Access Compliance Report

Public Rights-of-Way

(Curb Ramps)

Intersection ID: 48132	Main Street: ACORN_CREEK_LN	Cross Street: HIGHLAND_CREEK_PY	Location: E
ADA ID: 57BA33F11CD6	Ramp Type: Perp	Initial Pass/Fail: Pass	Overall Compliance: No
		Severity Score: 0

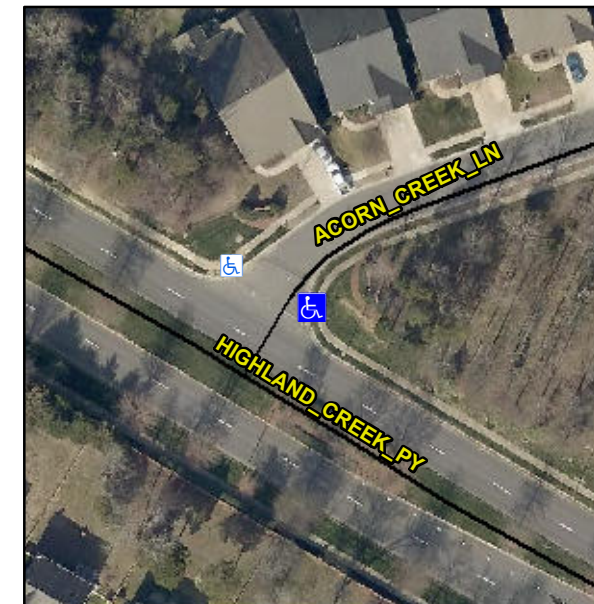
R304.2.1

Remove & Replace Landing.
